I wish to update my Relevant Representation submitted on 17 July

## HCDF

**Figure 11: Concept Design Option 2.1 – Landscaped**

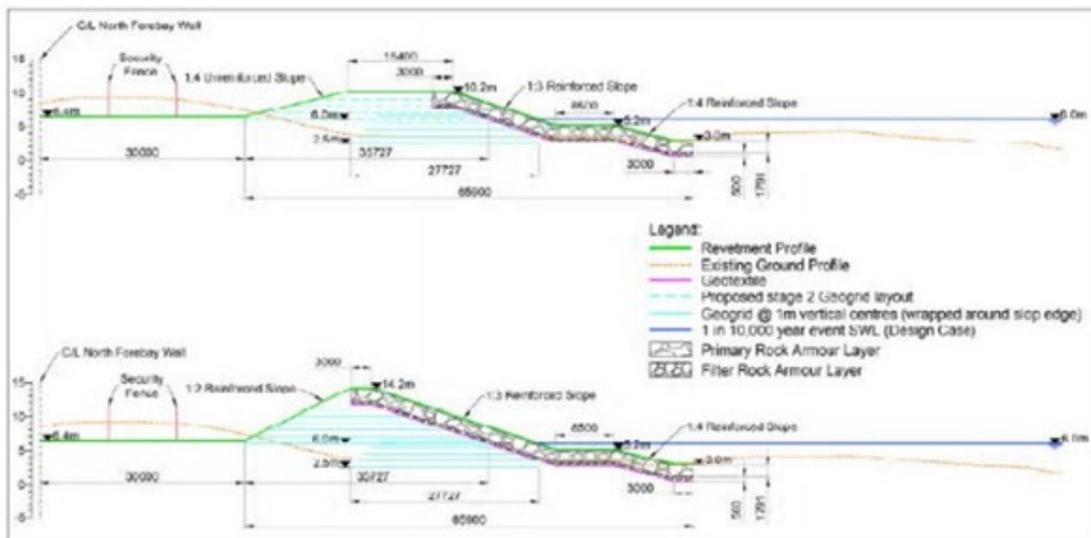
The HCDF in the DCO documentation (Bk6 Volume 2 Chapter 20 Appendix 20A Figure 29) is an incomplete conceptual design with fundamental flaws. It is unready for DCO assessment/approval. It is less advanced than the pre-February 2017 Jacobs design SZC\_Bk5\_5.2\_Appx1\_7\_MDS\_Flood\_Risk\_Assessment\_Part\_1\_of\_14.Appendix A page 34 adopted by the applicant in February 2017.

- The foundation design is indeterminate. There is reference to possible piling of the HCDF - Volume 2 Chapter 3 Description of Construction paragraph 3.4.41. Engineering feasibility, environmental impact and the associated risks with substantive temporary works lowering sea defences has not been presented/examined.

- The foundations are underlain by high compressible silts/clays and peat – no additional height for long term settlement has been stated or allowed for if a non-piled foundation is adopted.

- The DCO analysis sections of the adaptive defence level of 14.2m do not appear to include rock armour above 10.2m - it will fail when wave heights exceed 10.2m. The DCO documentation indicates such events are expected to occur.

- The toe depth of the HCDF has been inadequately assessed in the DCO documentation – only the 2018 ‘Best from the East’ storm wave heights has been modelled to determine toe erosion and not future wave heights. In my view the HCDF toe is of inadequate depth, as with Jacobs 2017 design. ESC coastal forum [REDACTED] at Key issue #2 concurs. Adequate toe depth is crucial to avoid catastrophic failure.

- The relationship between design life and return period events does not meet minimum UK/international design standards for defences with assets behind i.e. a maximum 5% probability of event exceedance. For Sizewell C HCDF design life a 4000 year storm event provides equivalence – this has not been modelled.

- The DCO documentation shows a ‘soft’ cover to the HCDF rock armour. Whilst not detailed a very heavy duty non-biodegradable geotextile has to be laid on the rock or the soft cover will be lost into the armour. Significant adverse impacts of the inevitable loss of geotextile to sea when the soft cover is washed away, as predicted by the DCO documentation, has not been considered.

- The impact of concave defence alignment between the BLF access road and main access road on wave heights amplification and thereby overtopping is not presented.
